**RICHLAND COUNTY
PLANNING COMMISSION**

FEBRUARY 3, 2004

Agenda

SD 04-108
LONGTOWN ESTATES
TMS 02600-05-10 & 03500-01-32

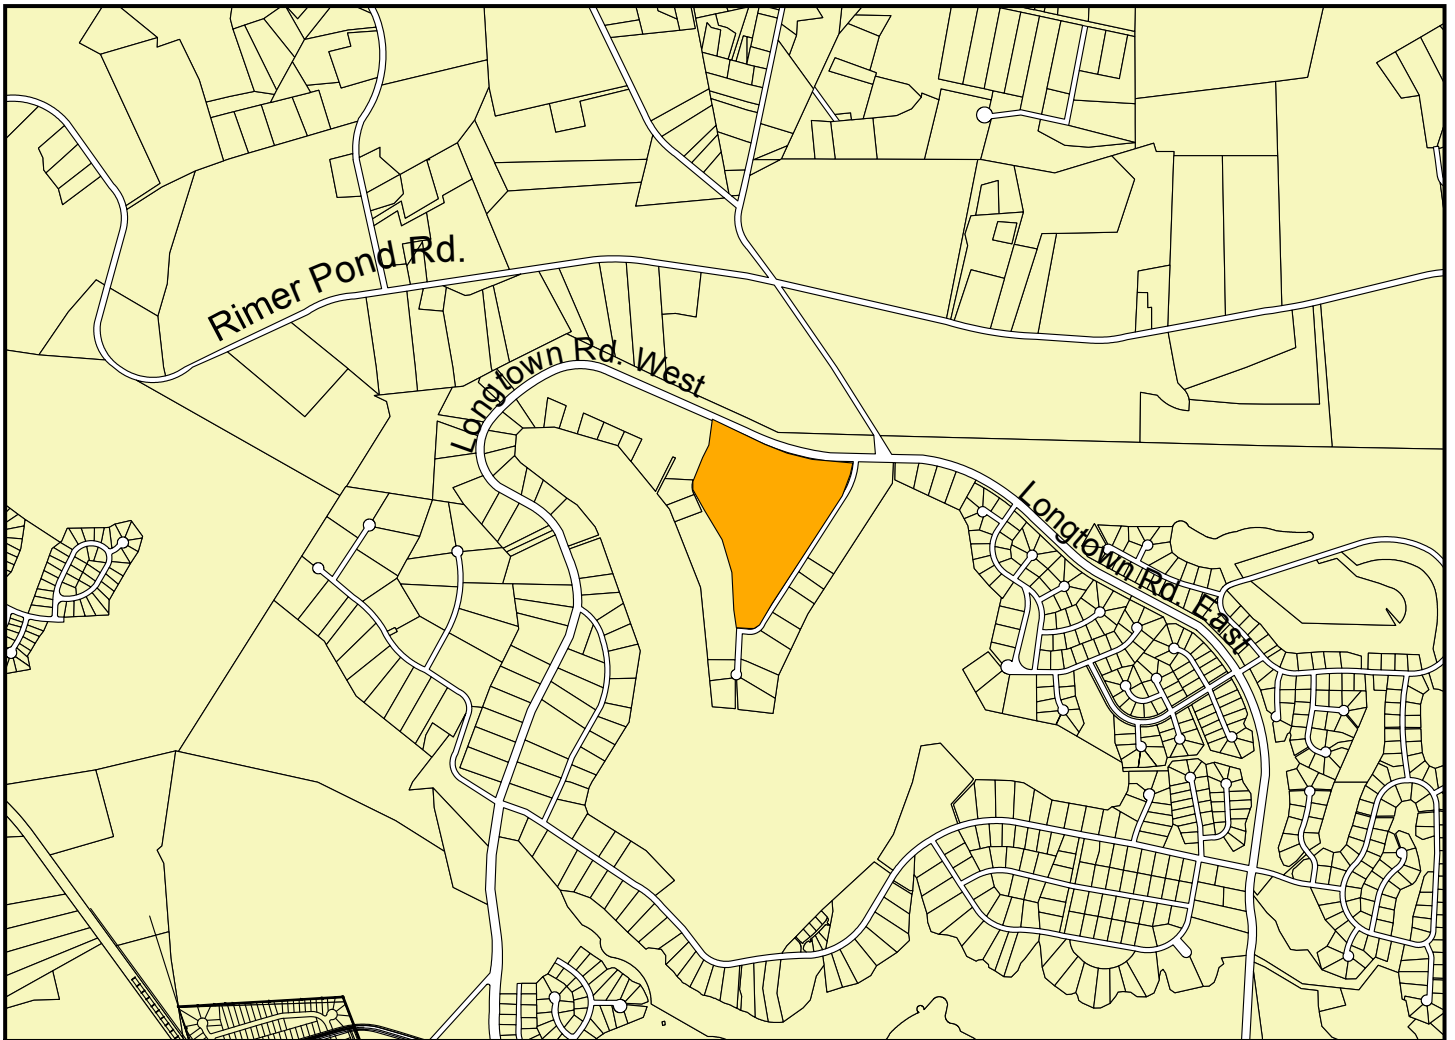
The applicant submitted a revised plat that substantially accomplishes the Commission's request. A copy of the revised plat is attached for your review.

The wetlands delineation on the site has been approved by the US Army Corp of Engineers. The common area designation is consistent with the applicable portions of the Longcreek Plantation Property Owners Association Deeds, Restrictions and Covenants

The Department recommends approval of the revised plat, subject to the Specific Conditions described below:

- a) **PRIOR to any site clearance activity being initiated**, the subdivision plats shall include tree protection certification statements provided by the Department; and
- b) The Department of Public Works must approve the stormwater management plans; and
- c) The Floodplain Manager must approve the flood elevation statement prior to any building permits being issued, or any clearing activity occurs; and
- d) DHEC must issue the sewer line construction permits; and
- e) DHEC must issue the water line construction permits; and
- f) The applicant should be required to dedicate a minimum of 30 feet and a maximum of 60 feet of right-of-way along the western leg of Overlook Drive, depending on a final determination of the property line, prior to any building permits being issued; and

SD 04-94
FISHER WOODS, PHASES 3A, 3B & 3C
TMS 22900-01-04

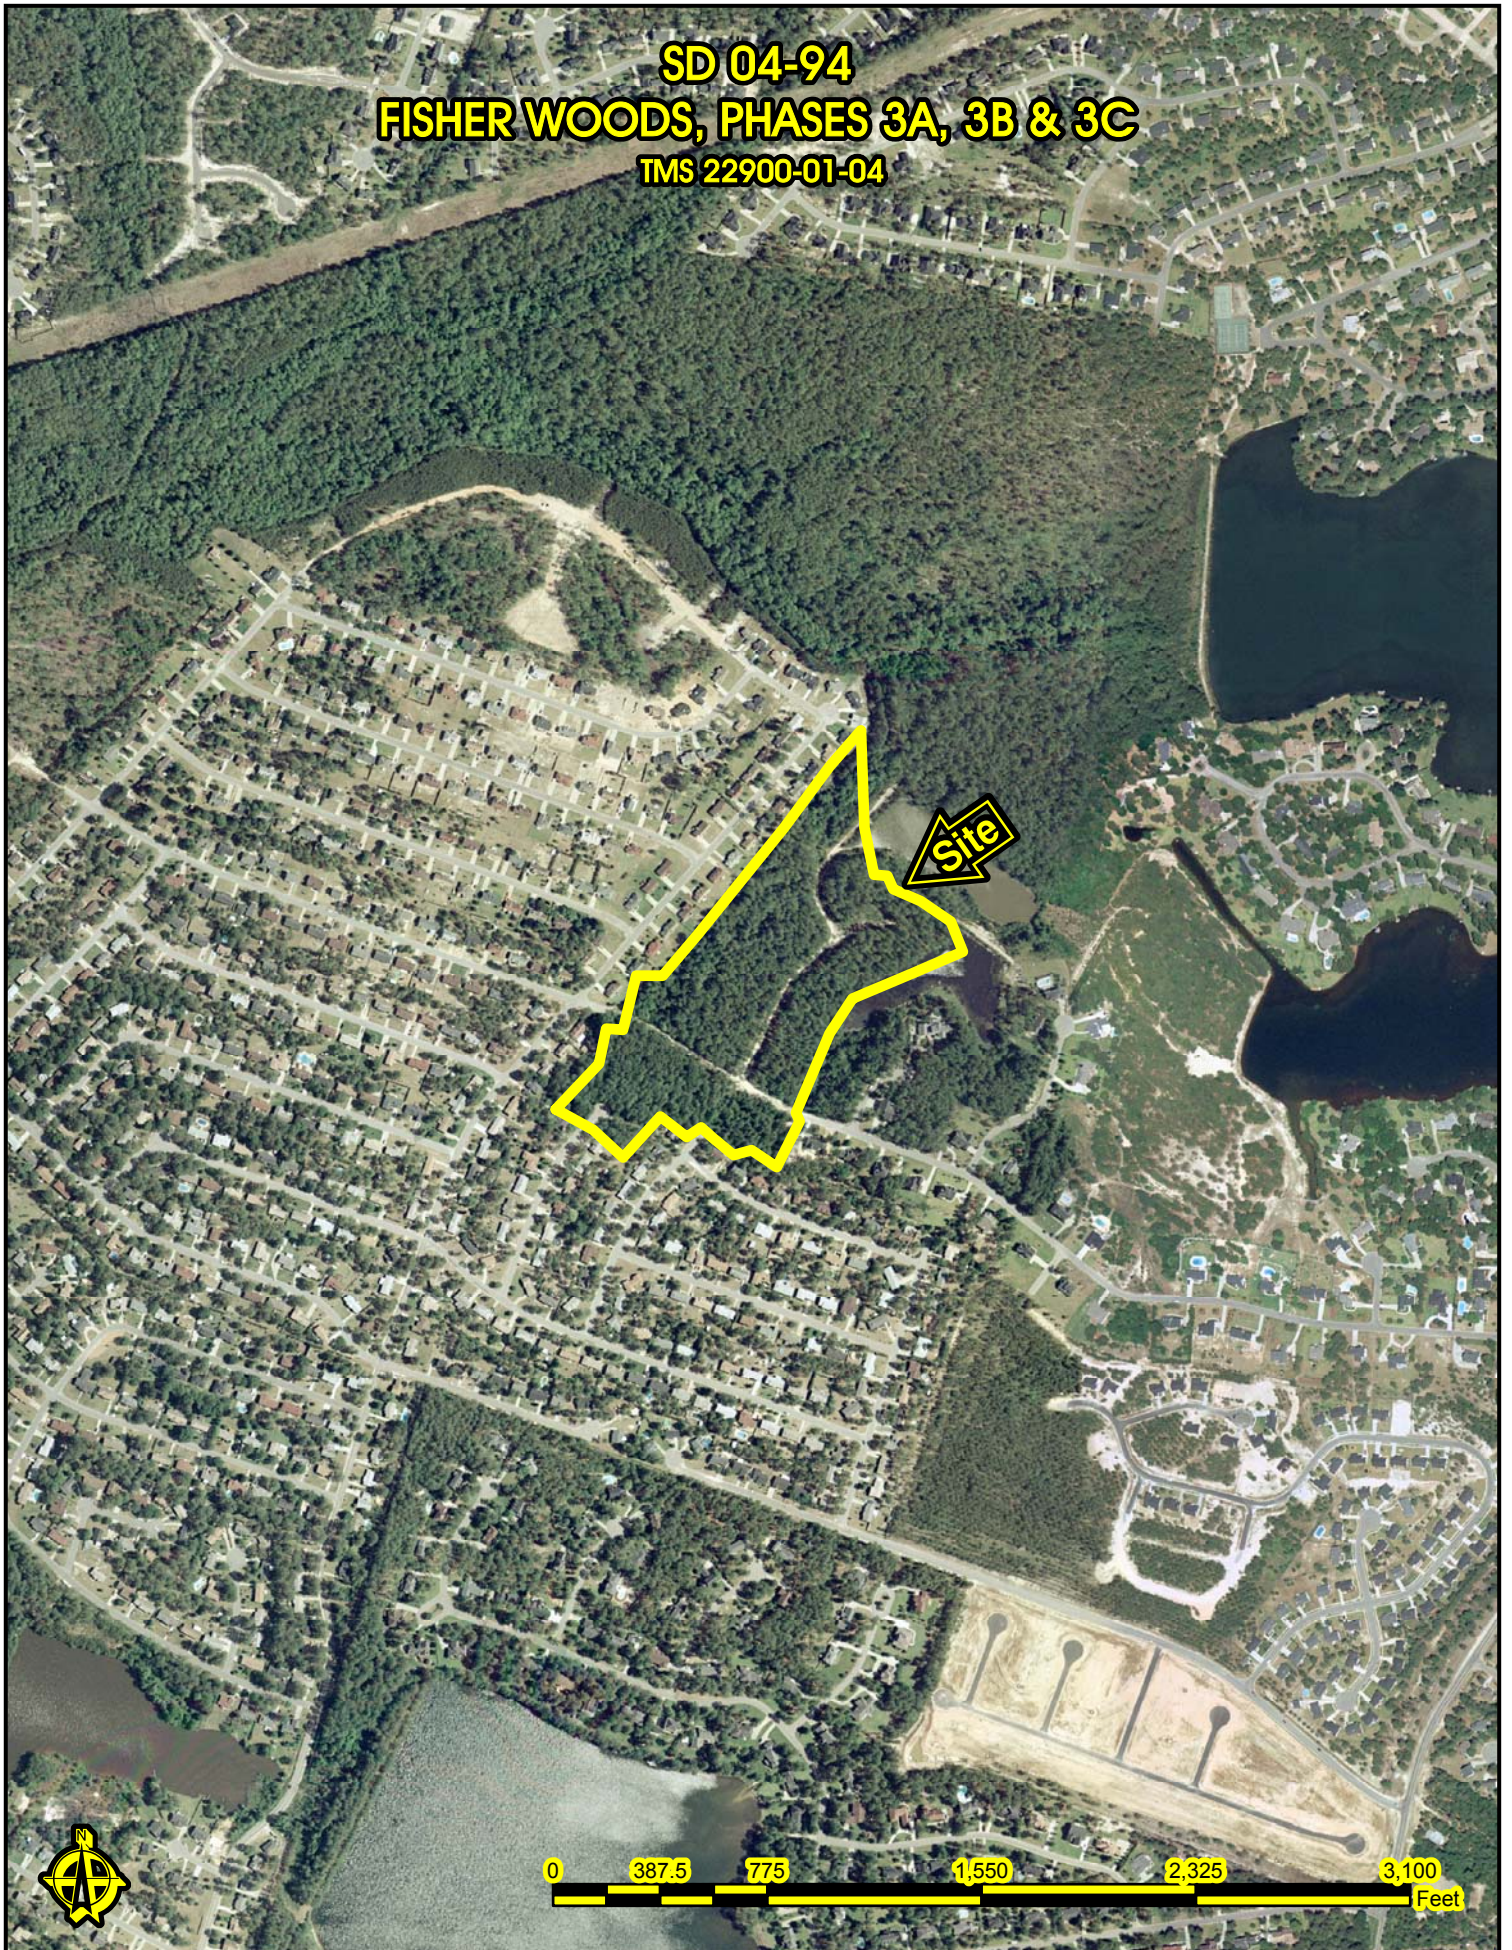
- 1) As of January 21, 2004, the Public Works Dept. had not approved the stormwater management plans.
- 2) As of January 21, 2004, the Floodplain Manager had not approved the flood elevation statement.
- 3) As of January 21, 2004, the City of Columbia had not approved the water line construction plans.
- 4) As of January 21, 2004, DHEC had not issued a construction permit for the sewer lines.
- 5) As of January 21, 2004, DHEC had not issued a construction permit for the water lines.

Upon receipt of complaints of clearing activities from neighboring residents, the Public Works Dept. issued a Stop Work Order on January 13, 2004. The investigation disclosed that the developer, or his contractors, had failed to get any approvals from the County to begin clearing activities. It is not unusual for developers to begin clearing activities prior to the project being considered by the Planning Commission. However, in this case, **the developer did NOT get a Streets, Drainage and Sediment Erosion Control Permit**, commonly known as the Grading Permit, from the County.

- a) The plat must establish the setbacks, either graphically or by notation, for each lot; and
- b) The Department of Public Works must approve the stormwater management plans; and

- c) The Floodplain Manager (Harry Reed @ 576-2150) **must approve the flood elevation statement prior to building permits being issued**; and
- d) The City of Columbia must approve the water & sewer line construction plans; and

SD 04-160
BROOKHAVEN, PHASE 1
TMS 17500-03-42

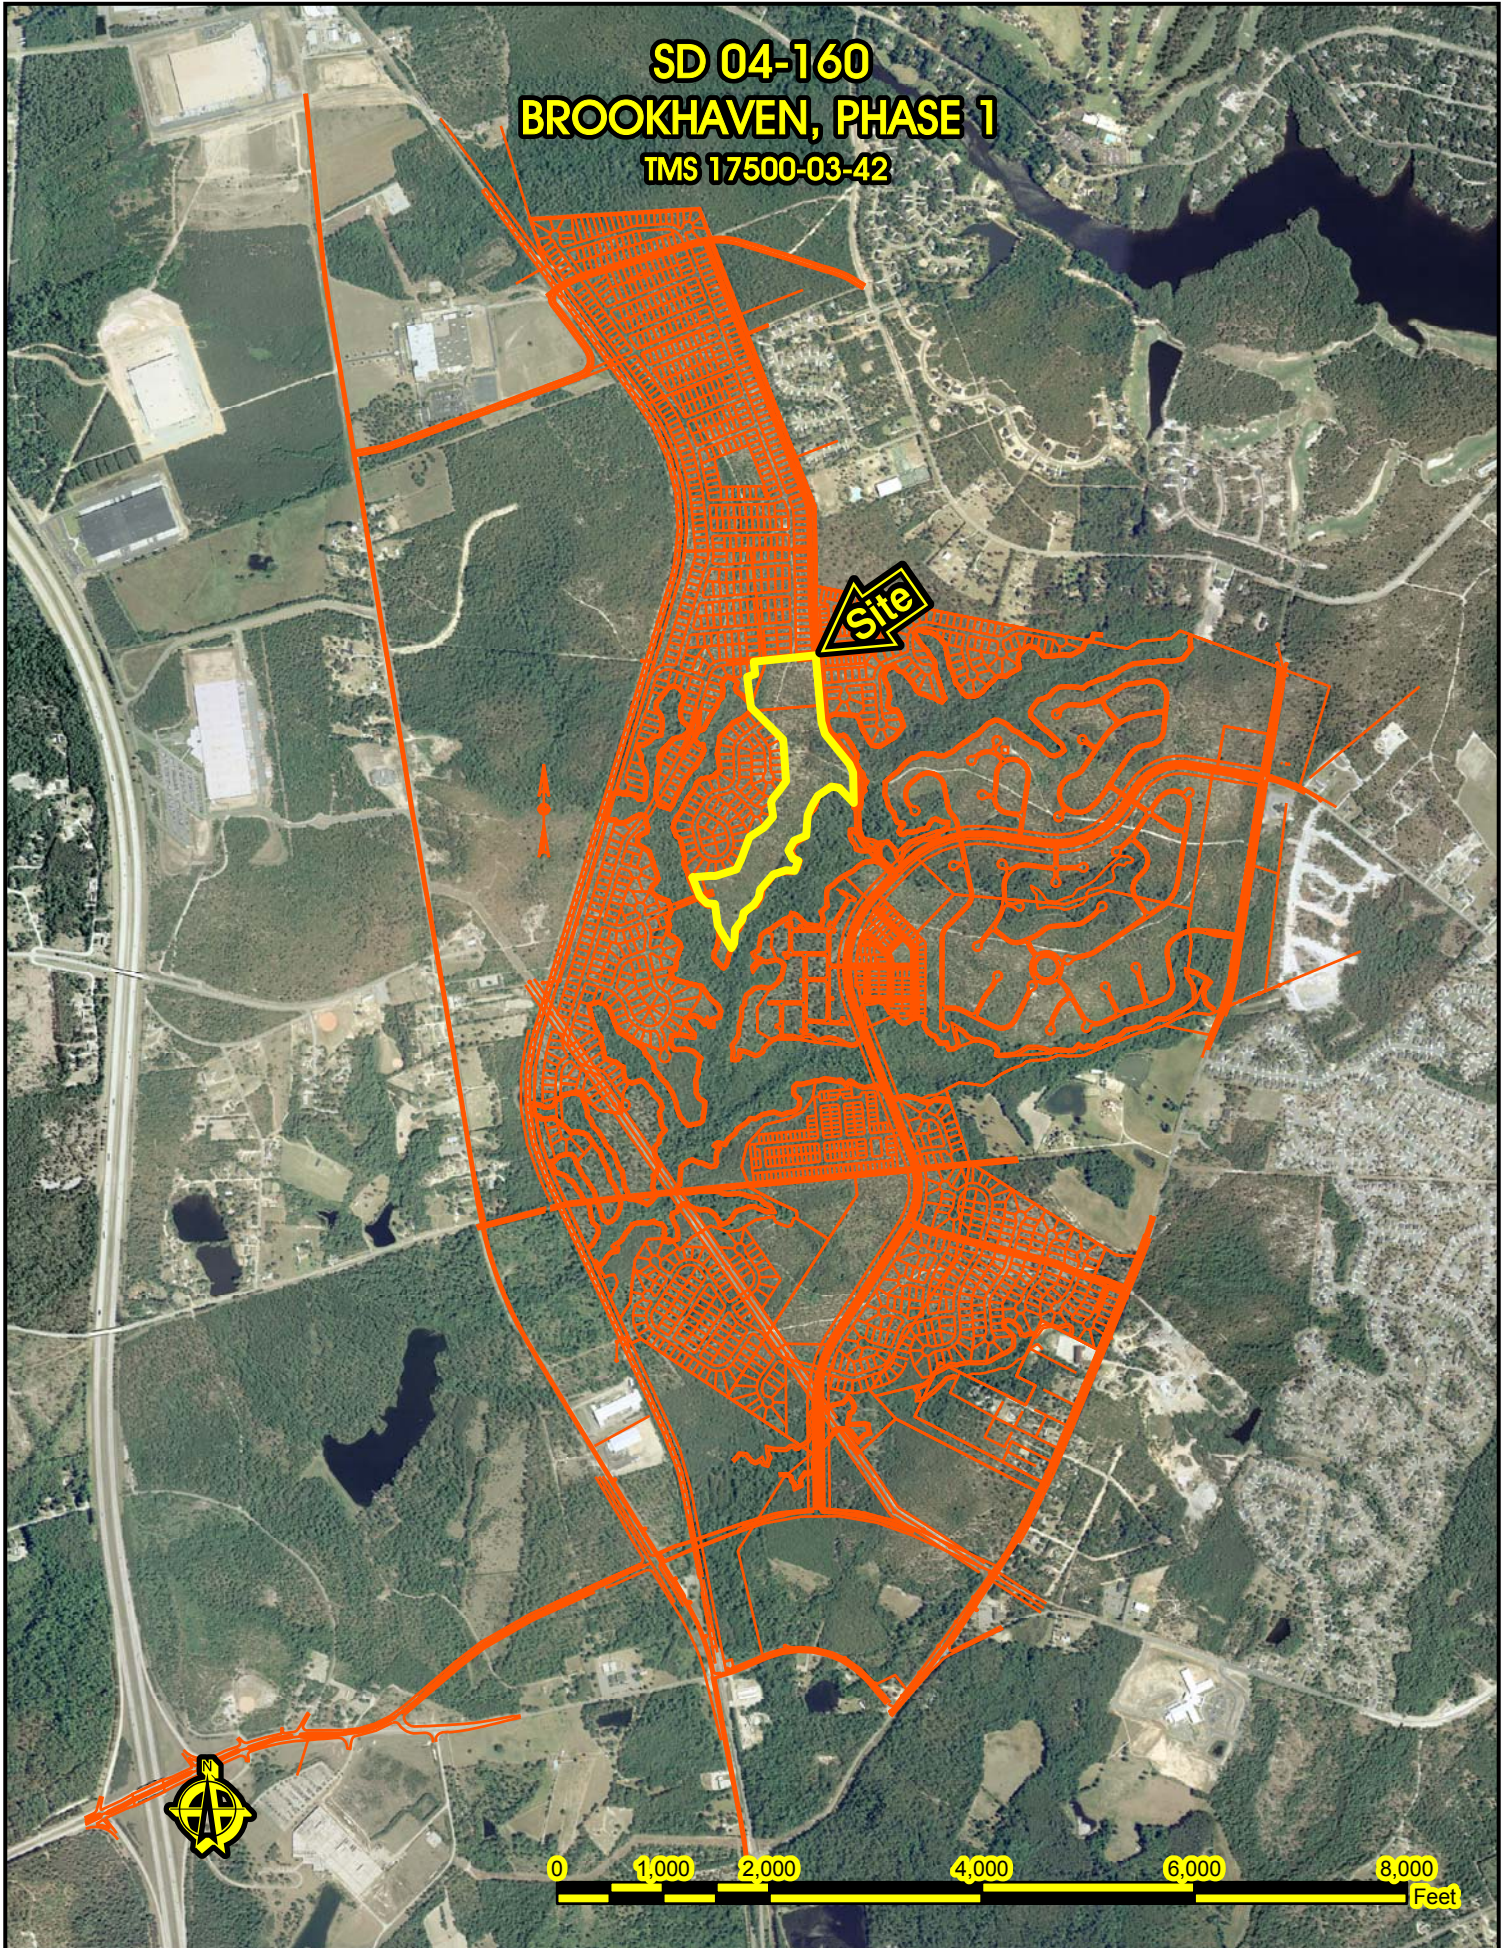
The **proposed subdivision is not consistent** with the Proposed Land Use Map because it is a residential project located in an area designated for industrial development. The state law requires projects to be consistent with the provisions of the Comprehensive Plan, including the Map. **Even though the County rezoned the entire project to PUD-2, the I-77 Corridor Subarea Plan Proposed Land Use Map was not changed to a residential as required by state law.**

- 1) As of January 21, 2004, the Department had not received the Public Works Dept. approval of the stormwater management plans.
- 2) As of January 21, 2004, the Floodplain Manager had not approved the flood elevation statement.
- 3) As of January 21, 2004, the City of Columbia had not approved the water and sewer line construction plans.
- 4) As of January 21, 2004, DHEC had not issued a construction permit for the sewer lines.
- 5) As of January 21, 2004, DHEC had not issued a construction permit for the water lines.

- b) The Department of Public Works must approve the stormwater management plans; and
- c) The Floodplain Manager (Harry Reed @ 576-2150) **must approve the flood elevation statement prior to building permits being issued**; and

- d) The City of Columbia must approve the water and sewer line construction plans; and
- e) DHEC must issue the sewer line construction permits; and
- f) DHEC must issue the water line construction permits; and
